# GTR Pressure Cycling Discussion GTR Meeting – 5<sup>th</sup> Informal Working Group

March 4<sup>th</sup>, 2019

## Issue with GTR Pressure Cycle Test Procedure

#### Pressure Cycle Profile

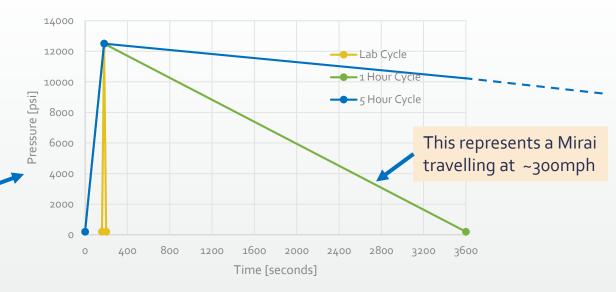
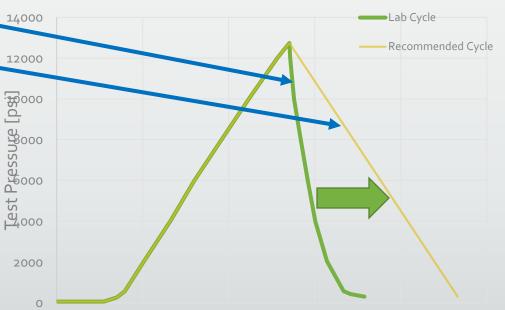
- The depressurization slope represents a rate of 2,500 psi/sec.
- The overall cycle rate of 2 cycles per minute used is not a concern, as long as the fluid temperature in the tank is controlled.

- One hour cycle (3 minute fast fill and 57 minute discharge) vs 5 hour cycle vs tested cycle
- Profile used during actual testing
- Recommended profile to minimize the effect of pressurization
  - Quantum controls the pressurization with a variable flow valve

- How do we prescribe a test protocol to not fail a validated tank in accelerated testing?
- Quantum is requesting a modification to the wording in the GTR standard to refine the pressure profile and temperature controlling requirements:
  - Provide more uniform up/down ramp rates.
  - The temperature inside the tank is measured and controlled so that the tank does not see an over temperature condition.

Temperature Monitoring and Control

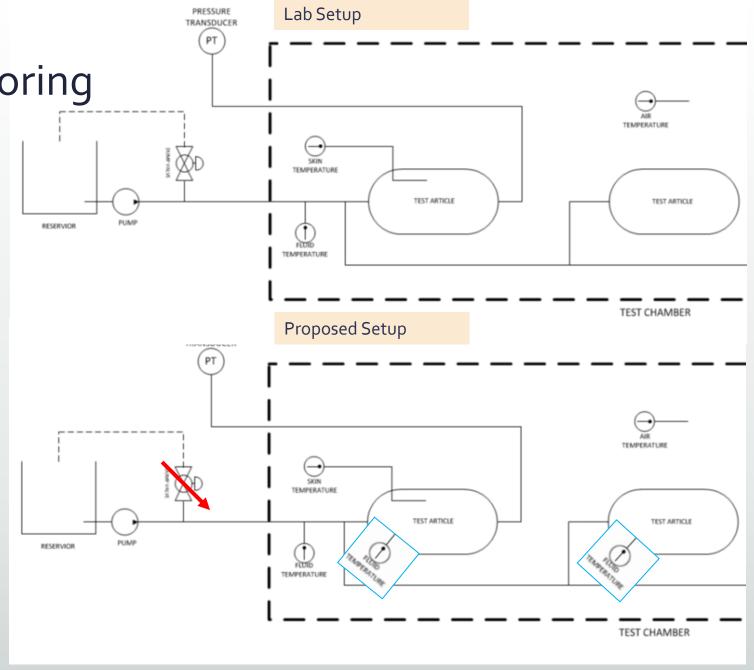
- The temperature of the fluid should be measured inside every tank common to the fluid port.
- The fluid inside the tank can see temperatures higher than the fluid measured before entering the tank
- The skin temperature will always be lower than the fluid in the tank being heated by the heat of compression.
- Quantum has seen in external lab testing where the temperature was so high that caused the water to boil.
- In this arrangement, due to tank #2 having over twice the volume of tanks #1 and #3, the tank would show increased effects of heat up due to fluid flow. Since tank #2 was not instrumented, the temperature inside the tank would be unknown.
